LAND TO THE SOUTH OF LITTLEHAMPTON ACADEMY

TRANSPORT ASSESSMENT ADDENDUM

LAND SOUTH OF LITTLEHAMPTON ACADEMY, FITZALAN ROAD, LITTLEHAMPTON

Ref: 20/5433/TN07

Drawing No.	Rev.
6800	P04

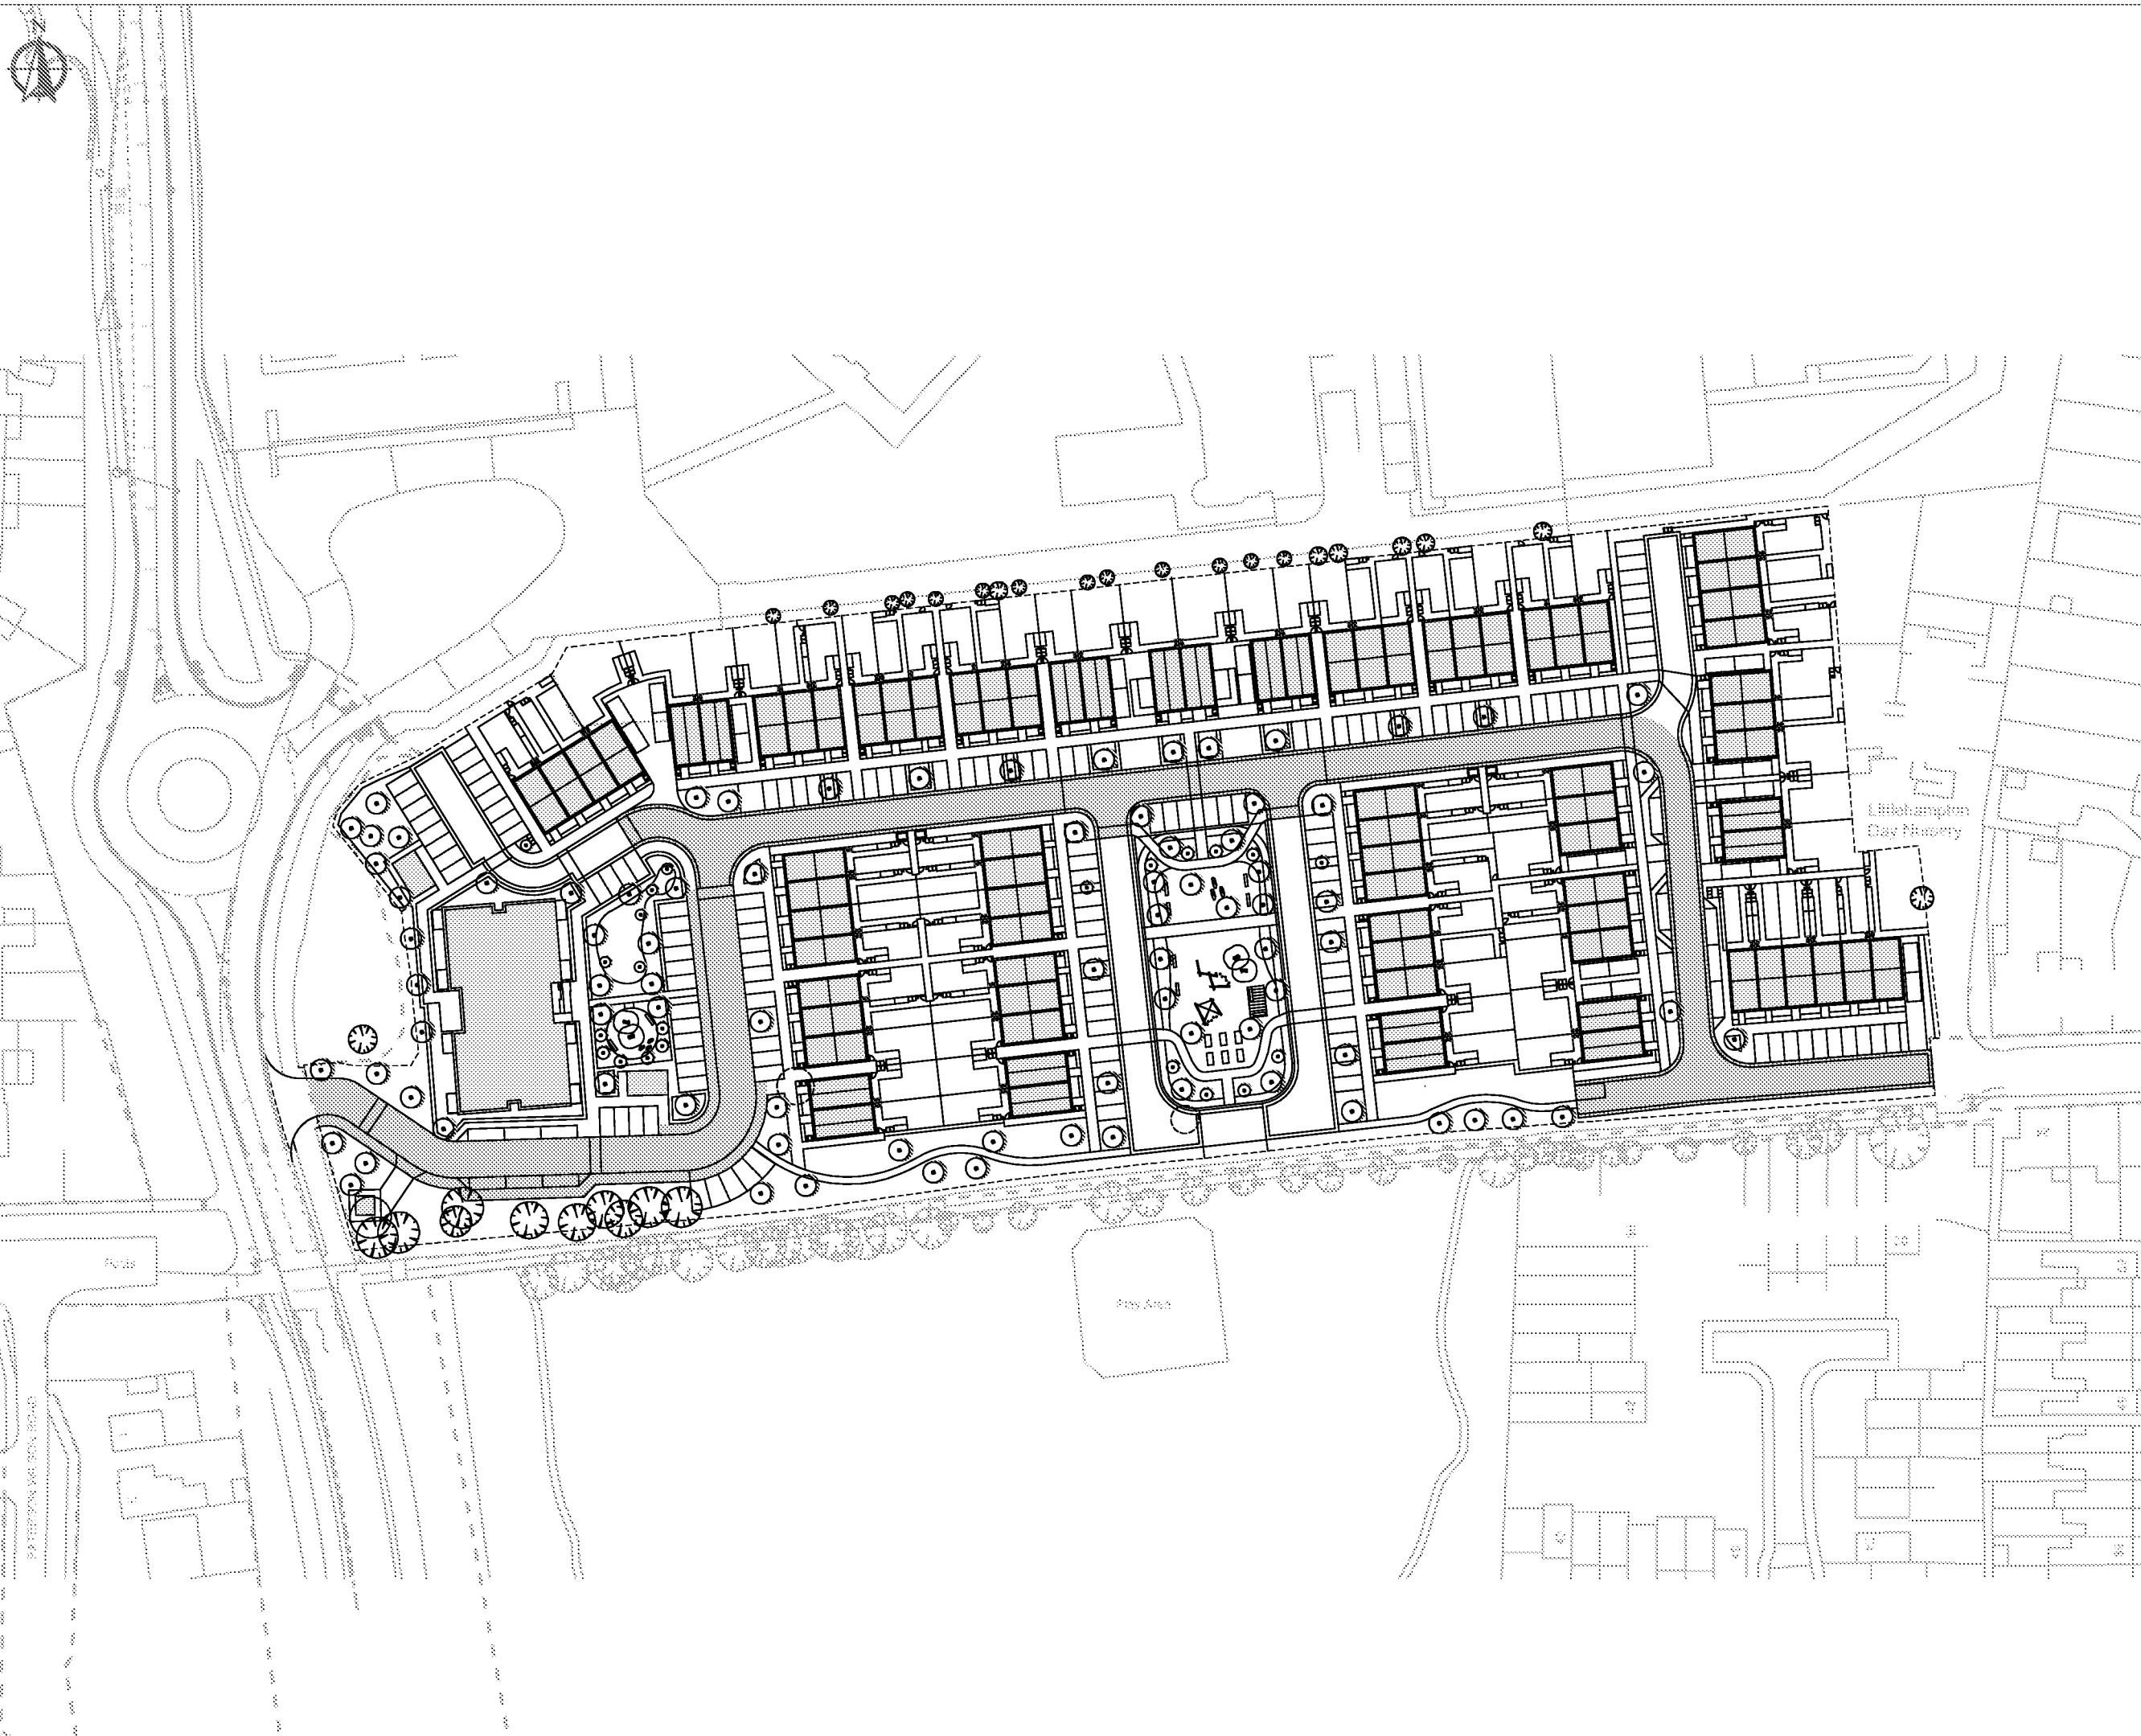
13. Whilst the adoption of the proposed access roads as public highway is not a material planning consideration, it would still be useful to understand the applicants intentions in respects of highway adoption. Where appropriate, comments are made regarding aspects of the design and highway adoption. It is accepted that some of these comments may not be applicable if the internal roads are being retained under private maintenance.

15. The only specific comment regarding the layout relates to specifics in terms of parking.
 - With those spaces running immediately adjacent to the carriageway edge, if the applicant's intention is to offer the roads for adoption but to allocate parking spaces to specific properties, a margin of at least 0.5 metre would be required between the carriageway edge and what will then have to be private parking spaces (as allocated parking cannot be provided within the public highway). This margin would be required to enable WSCC to maintain the highway edge.

- With respects to the above point, it should be noted that if the spaces are to be allocated/private, the preference would be for the footway (which is likely to be adoptable) to run adjacent to the carriageway edge (which would also be adoptable). The issue with the layout as shown is that this introduces the potential for private car parking spaces to be sandwiched between the adopted footway and carriageway. Again, comments are made on the basis that the layout will be adopted, which may not be the case.

- Car club parking spaces are also indicated. From the correspondence, the car club operator is willing to operate a single vehicle from the site initially, increasing to two vehicles if demand justifies it. It's recommended that only a single car club space is initially marked out. If the roads are to be offered for adoption, a traffic regulation order would be required to reserve the respective parking space for use the car club use.

- 5.3 As illustrated on the attached drawing, the access road is provided with footways for the initial section of the site, before becoming an adopted shared surface. Footpaths would also be provided within the private (unadopted) areas, segregated from the shared surface, providing direct access to dwellings and through landscaped areas and play space. With respect to WSCC's specific comments, these are confirmed as follows:

- 2 All private car parking spaces running immediately adjacent to the carriageway edge would be provided with a minimum 0.5 metre margin, as illustrated on drawing 6800. A copy of the more detailed Landscape GA plans is also attached at Appendix F for reference;

- 2 All sections of footway to potentially be adopted is sited adjacent to the carriageway edge to avoid private spaces being 'sandwiched' between adopted areas. It is noted that the three spaces close to the entrance of the site are proposed for adoption, which would include the car club spaces to ensure that they can be controlled and maintained by the Highway Authority, in liaison with the car club operator, in perpetuity;

- 2 As confirmed by WSCC, a single car club space would be marked out with a traffic regulation order to be put in place on to reserve the additional space for the use by a car club in the future. Full details of the car club spaces would be provided through the full Travel Plan.

Client			
Borlase			
Project			
Land to the south of Littlehampton Academy			
Drawing Title			
Proposed Access Arrangements Current Link Road Alignment			
Drawing No.		Rev.	
6901		P1	
7/2006	Drawn By	Checked and by	Author
As Shown	SJ	CB	AN

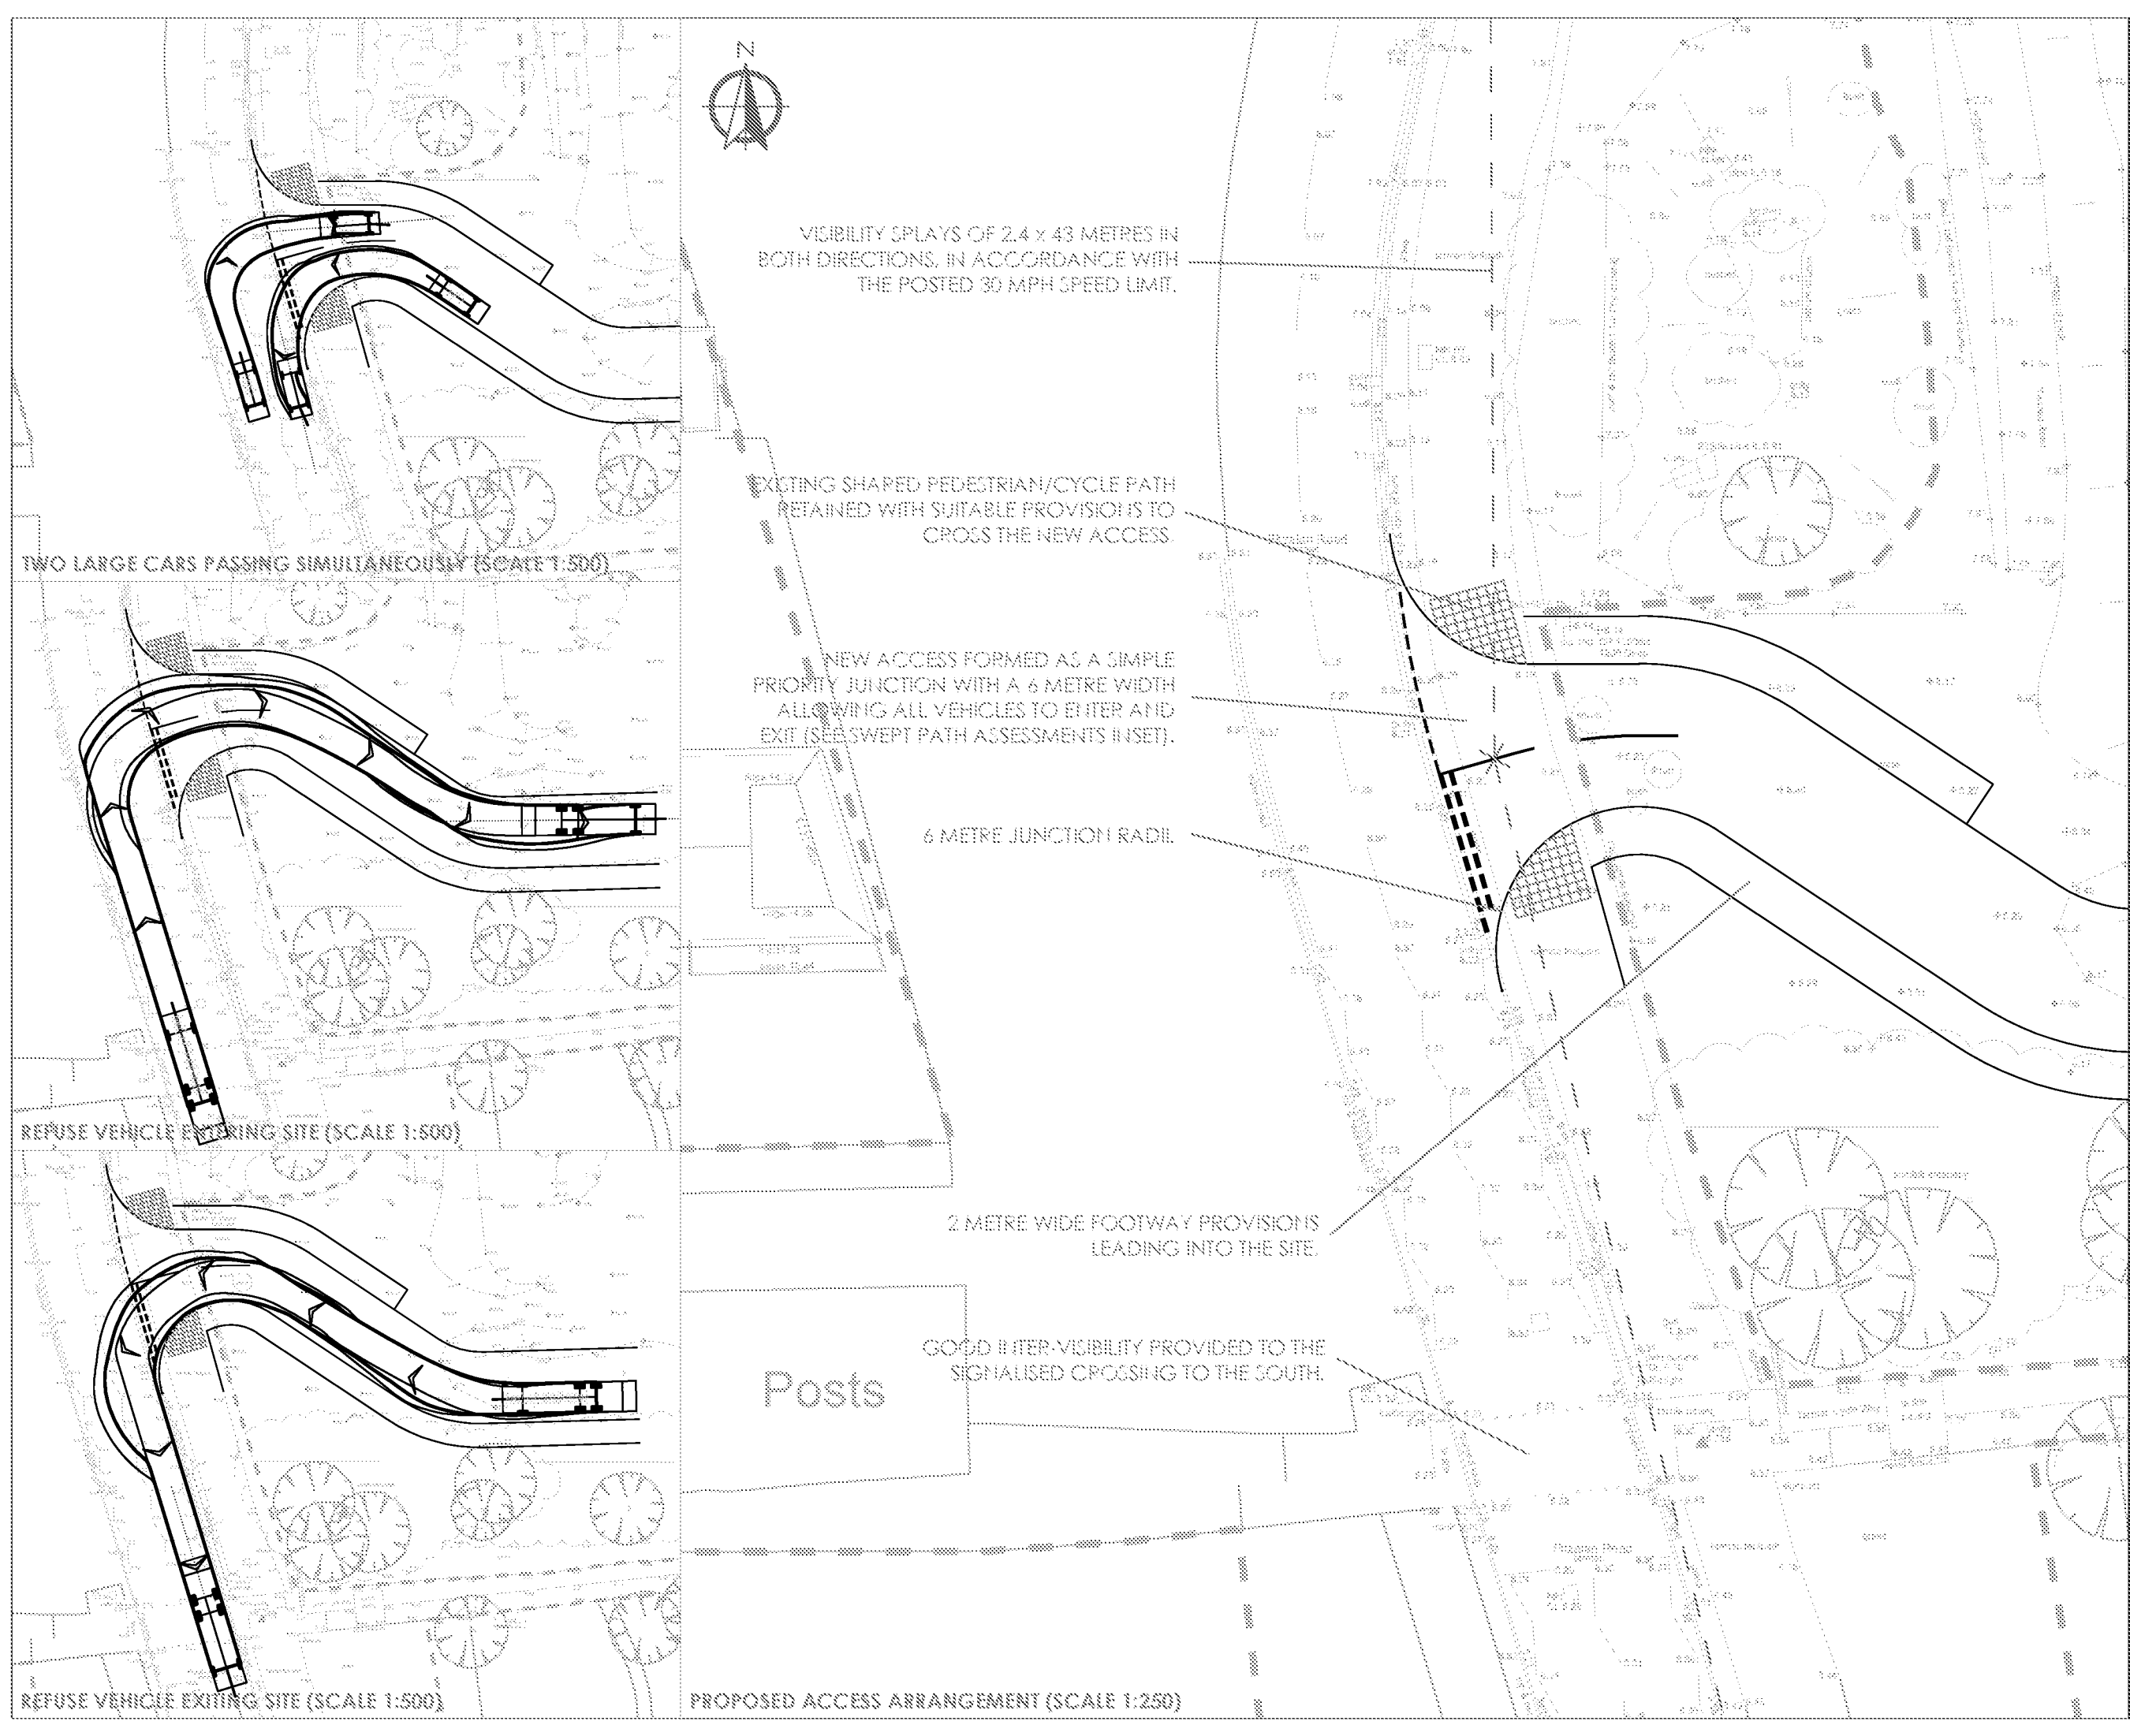
Location:	Verge to back of footway north of proposed access.
Summary:	Possible obstruction to visibility. The visibility splay for the proposed development site access junction passes over private land to the north. Any obstructions to visibility here such as landscaping/vegetation or development could obscure visibility between traffic exiting the school and vehicles exiting the development access onto Fitzalan Road. This could lead to failure to give-way type collisions.
Audit Team Recommendations:	Ensure that adequate visibility splays are maintained clear of any obstruction.

The Audit team raised concern that the proposed visibility splays looking to the north (current alignment of the Fitzalan Link Road) would cross over private land. However, as confirmed by drawing 6801 and the Highway Boundary records at Appendix B, the proposed visibility splays would cross land that is entirely public highway, with no requirement for the use of third-party land.
